MEMORANDUM

SUBJECT: **AP 14-01:** Applicant's appeal of Condition of Approval No. 37 of the Community Development Director's land use approval on November 14, 2014 of file number **SP 14-01**, a Site Plan and Design Review application for 121 Apartment Units and 62 Live-Work Units on 9.7 acres (Zoned MUC-1).

FILE MEMORANDUM

Technical Memo

FIGURE 1: Project 1 and Project 2 Location Map

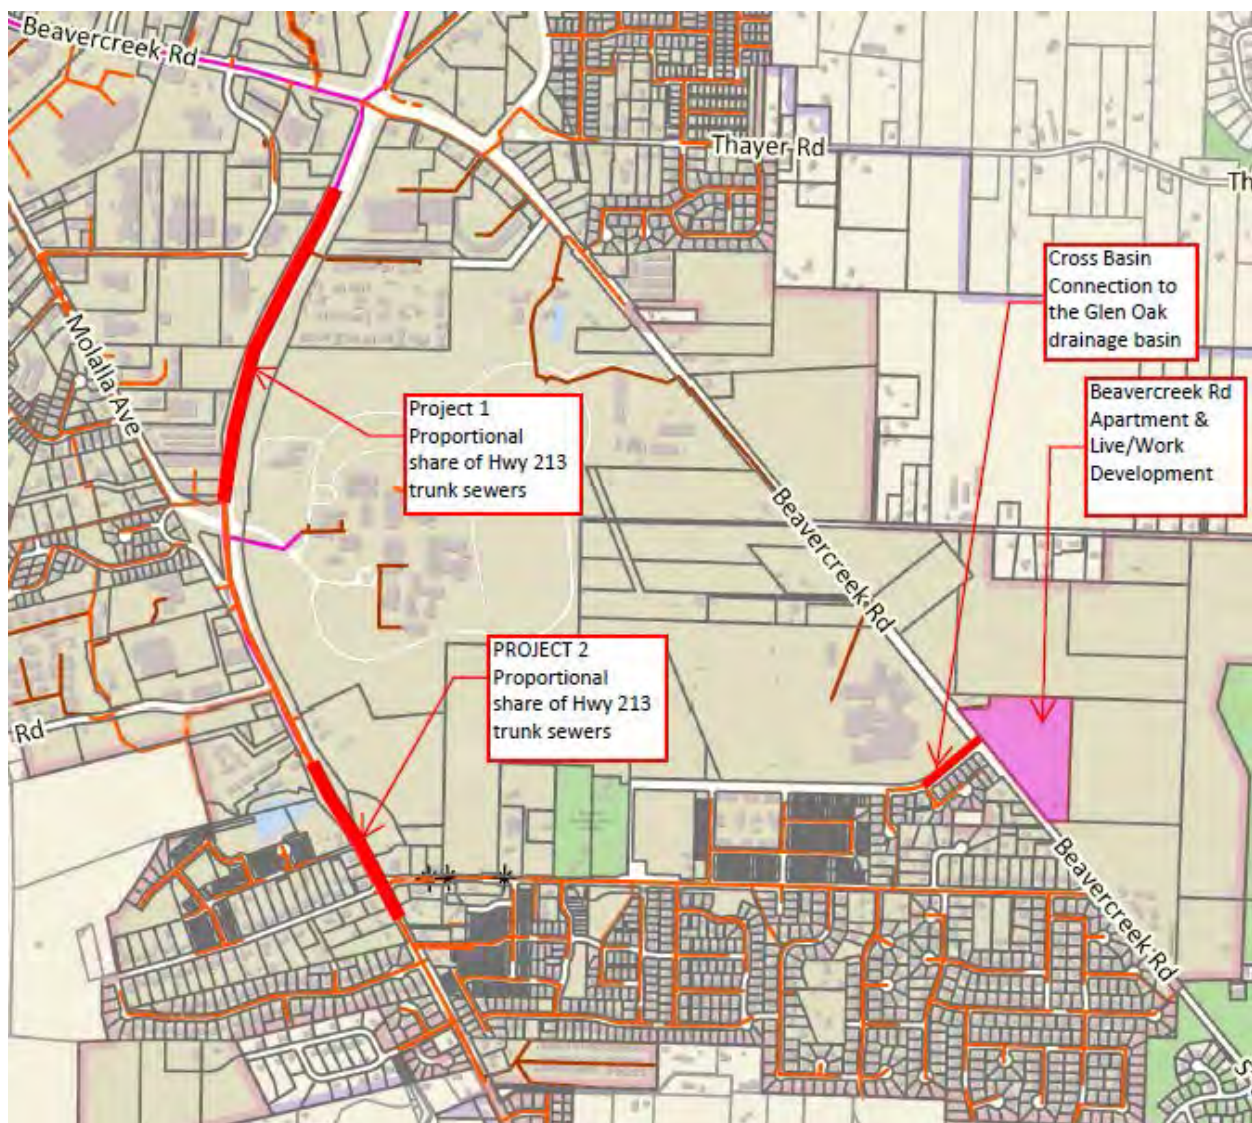
Figure 1 shows the locations of the upsizing projects. Project 1 being 2,400 feet of 21-inch pipe to be upsized to 24-inch pipe, and Project 2 being 800 feet of 12-inch pipe to be upsized to 15-inch pipe.

Project 1 capacity improvements result in the elimination of excessive surcharging conditions in upstream sewers in the future buildout conditions. BRCP peak flows of 421 gpm is estimated to be 69% of the buildout peak flows that contribute to the excessive surcharging that requires Project 1 to be constructed. The City anticipates reducing flows through I/I abatement program, although the reduction in I/I is not expected to offset the impacts of the additional BRCP flows, therefore BRCP flows impacts the collection system and contributes to the excessive surcharging conditions that requires Project 1 to be constructed.

Project 2 capacity improvements result in the elimination of excessive surcharging conditions in upstream sewers in the future buildout conditions when the BRCP peak flows of 421 gpm are added to the Glen Oak basin. Project 2 is not required if BRCP flows are not conveyed to the Glen Oak basin. Therefore the BRCP peak flows of 421 gpm is estimated to be 100% of the buildout peak flows causing the excessive surcharging in the collection system that requires Project 2 to be constructed.

Staff finds the Condition of Approval No. 37, imposing a fee-in-lieu of \$545,000, is not in excess of what is required by code Section 17.62.050 A. 14. Staff finds the fee-in-lieu amount is the needed requirement for the Applicant to provide their proportional cost share of improvements for modification and/or replacement of the existing off-site sanitary sewer system to provide adequate public sanitary sewer facilities for the development proposal. Staff recommends the City Commission deny the Appeal (AP 14-01), uphold the Community Development Director's decision to conditionally approve the applicant's request to construct 121 Apartment Units and 62 Live-Work Units on 9.7 acres on the east side of Beavercreek Road, with no change to the conditions of approval for Condition of Approval No. 37.
